UN Global Technical Regulation No. 2

Proposal for an amendment to Global Technical Regulation No. 2

Submitted by the expert from Japan*

Annex 13, paragraph 1, Figure A13-1, amend to read:

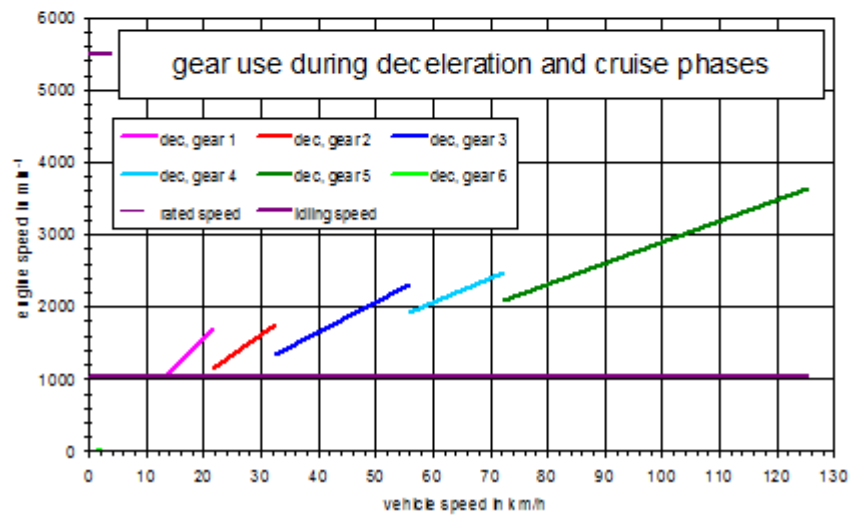
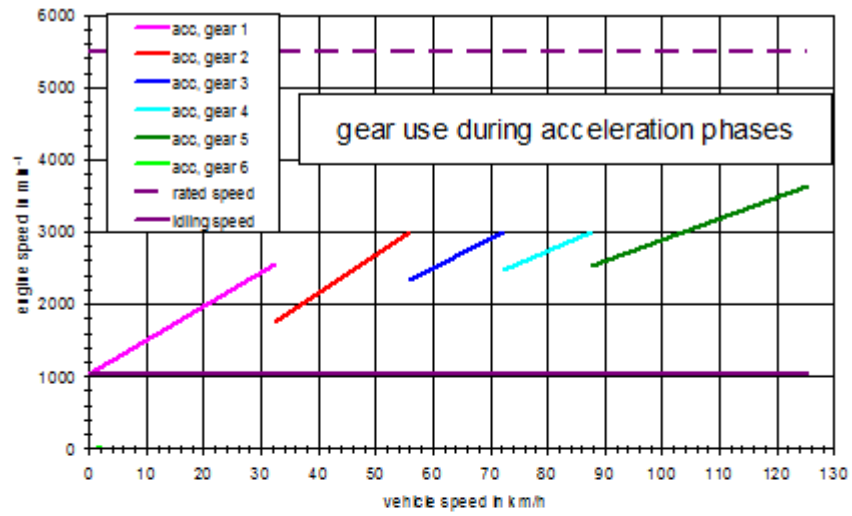
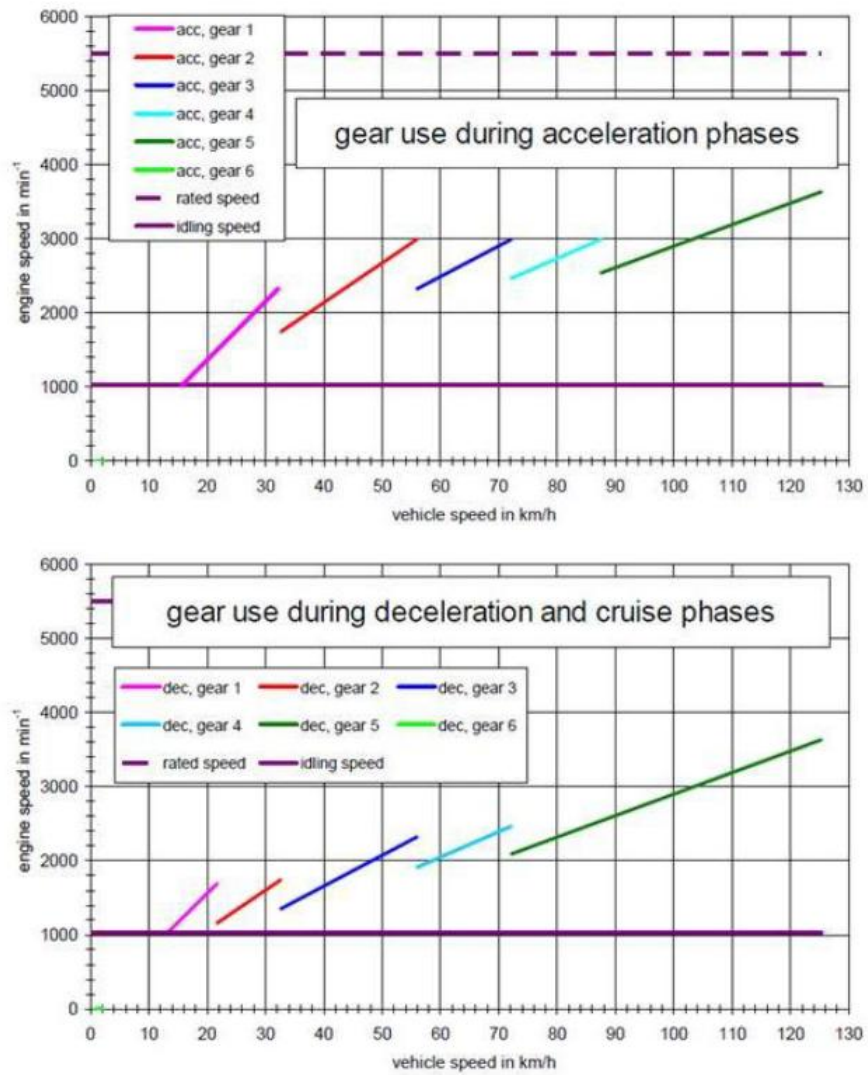
2. Annex 13, paragraph 1 Figure A13-1

In the upper figure for "gear use during acceleration phases", the acceleration gear 1 starts from zero, which is not correct.
